GTR#13 Phase 2 Proposal for Fire Test

South Korea

March 15, 2021

Figure 7. Temperature profile of fire test (from Fire Test Working Draft 03122021)

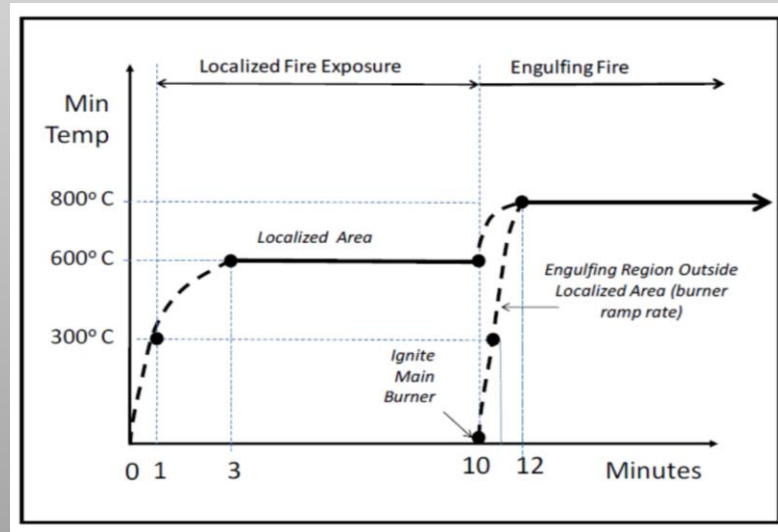
- GTR#13 Phase 1 utilizes temperature-based fire test condition
- GTR#13 Phase 2 added HRR per unit area condition of burner to existing & additional temp conditions
- Most important in PASS/FAIL fire tests is actual heat energy/flux applied to test specimen (NOT temp)
- At LOW heat flux, surface temperature may be high enough to show thermal degradation, but thermal wave cannot penetrate due to not enough heat energy (temp NOT reliable)
- In many fire tests, the importance of energy-based approach has been considered (e.g., room corner test, cone calorimeter test, etc.)

Effect of Radiative Fraction in GTR#13 Fire Test

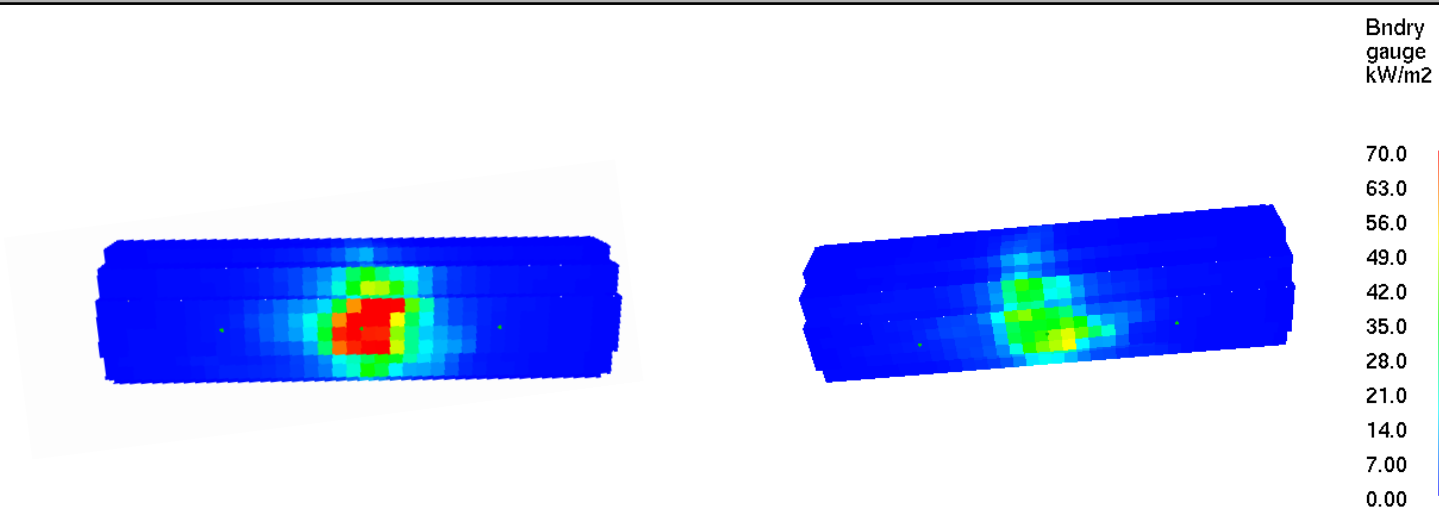
- FDS modeling results of GTR#13 fire test with 1.8 m long CHSS Tank
 - ✓ TPRDs are place at each end; therefore, flame was placed at center
 - ✓ Radiative fraction of the fire is changed from 0.3 to 0.1
 - ✓ Total Heat flux at surface reduces from red to green during local fire (70 to 30 kW/m², see below)
 - ✓ For FRP composite (~20mm thick), this may alter PASS/FAIL

Allowable Heat Flux Range on Bottom & Sides & Top of Container

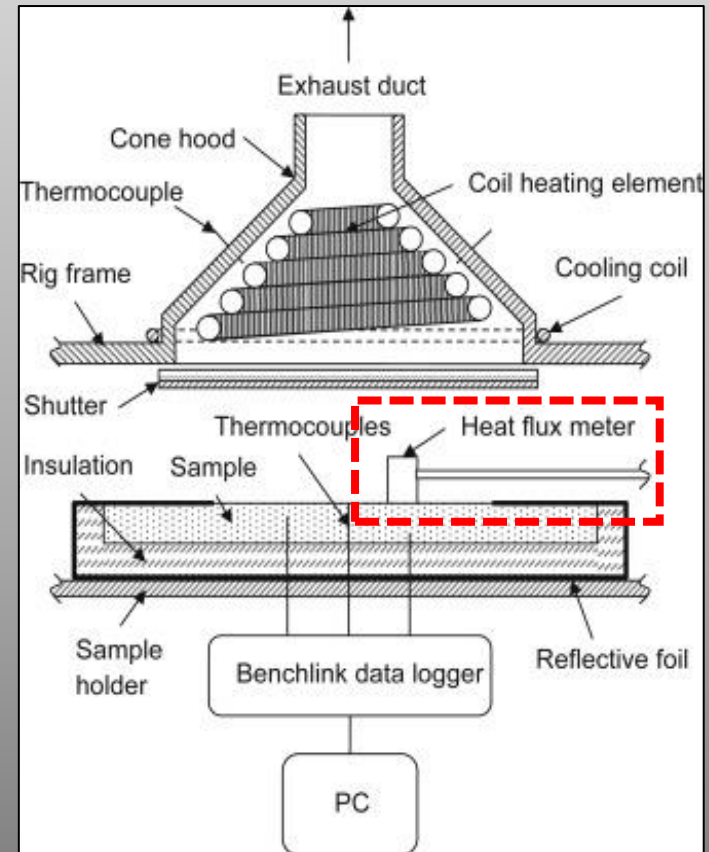
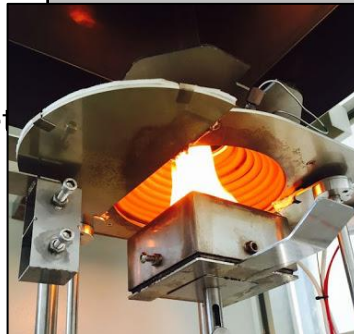
- To address repeatability (test-to-test) & reproducibility (lab-to-lab) of GTR#13 fire test, we need to set consistent fire test conditions throughout
- In the current working draft, we have temperature data & HRR/area (burner) data to match
- Need to fix radiative heat/energy transfer condition to sample surface → utilize heat flux measurements
- Why? Cannot control all the variables that may affect flame radiation to sample surface
 - ✓ E.g., Different laboratories have different source of LNG (variation in composition)
- **Make heat flux measurements (total & radiative) during pre-test checkout and/or before each test:**
6.2.5.1.4.5 Pre-test Checkout Process

add
